OLD RANCH STORAGE FILING NO 1 DEVELOPMENT PLAN

Planning Commission September 10, 2025

Staff Report by Case Planner: Tamara Baxter

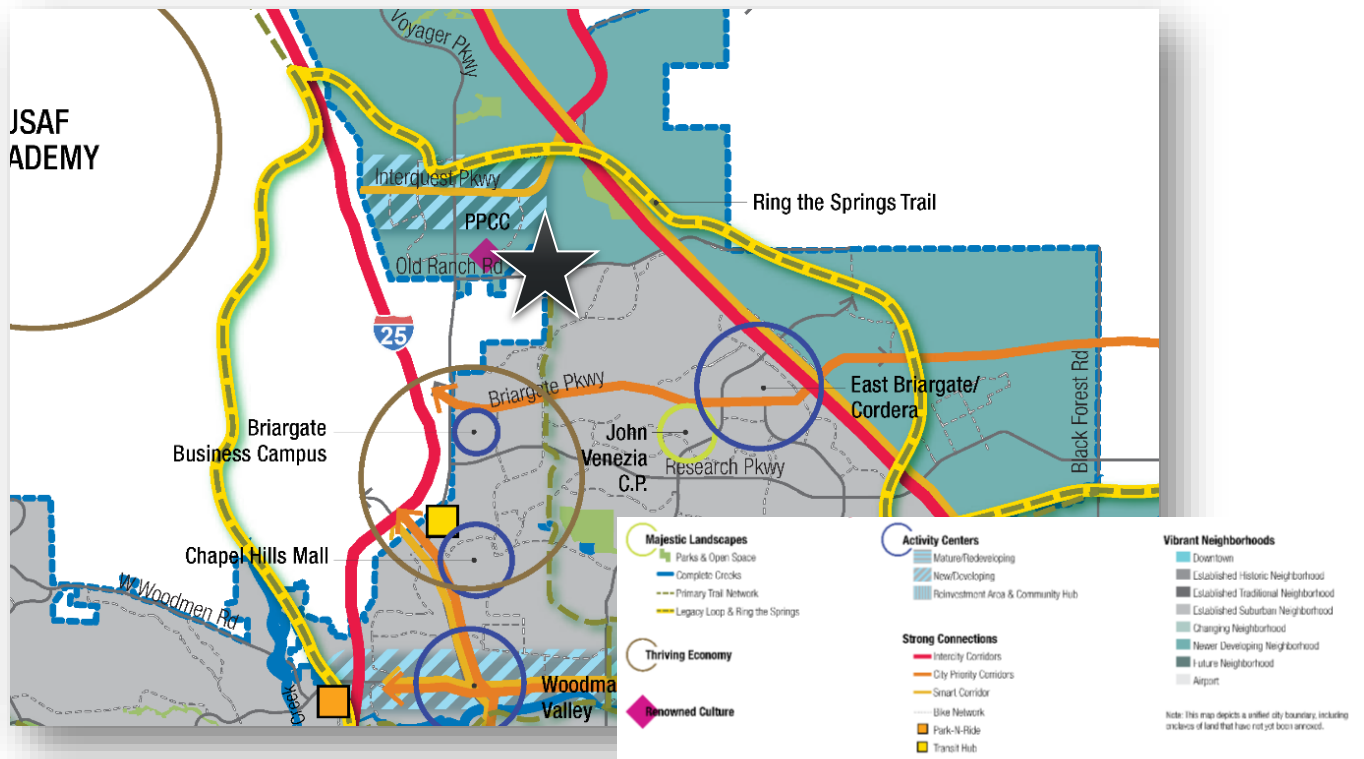
3. *Storage is adjacent to critical habitat for the ESA-protected Preble's jumping mouse (<https://ecos.fws.gov/ecp/species/4090>) but fails to disclose or study the effects of the project on its surroundings.*

Staff Response: The boundary of the Preble's jumping mouse habitat is located along the boundary of the Kettle Creek Open Space which is located to the northwest of the site approximately 1,900 feet away from the subject property. The existing single-family detached homes to the north and west of the subject site likely have more impact to this habitat than the proposed use.
